From: Venegas, Victoria, EMNRD
Sent: Wednesday, November 13, 2019 11:45 AM
To: 'Castro, Isaac (MRO)'; EMNRD-OCD-District1spills; Bratcher, Mike, EMNRD
Cc: Ashley Maxwell; blm_nm_cfo_spill@blm.gov
Subject: RE: Black Horse 7 Fed Com 1H Fire (1RP-5511), Lea/GREEN FROG CAFE FEDERAL #001H API 30-025-40828
Attachments: (C-141 Final) Black Horse Fed 7 Com No. 1H Closure DENIED 11.13.19.pdf

Black Horse 7 Fed Com 1H Fire (1RP-5511), Lea

A question regarding the Closure Report for: Black Horse 7 Fed Com 1H Fire (**1RP-5511**) Lea:

Surface Water Protection Map
Black Horse 7 Prod Cons 12H - Marathon Oil
Sec. 7 T20S R31E, Lea County, New Mexico

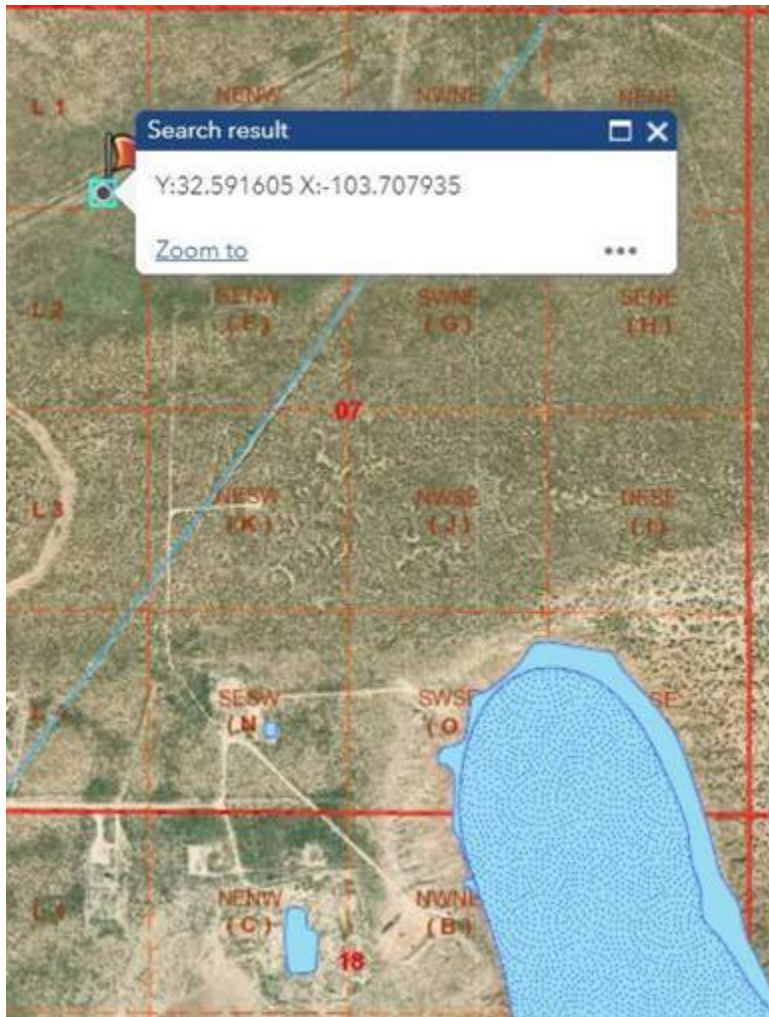
- In Figure 1 and Figure 2, the point of release is located approximately 500 feet West of Laguna Gatuna.

- The lat/long coordinates provided in form C-141 are: 32.59160463, -103.70793500. As you can see in the figure below (NMOCD Environmental Map), this location does not correspond with the point of release depicted in the closure report. Can you please clarify the actual location, the Lat/Long coordinates, of the release source?

- The Lat/Long coordinates reported in the initial C-141 do not correspond with the actual release location provided on the closure report. The point of release is located at GREEN FROG CAFE FEDERAL #001H API 30-025-40828. Please correct the C-141 (Lat/Long) and the Report and resubmit.
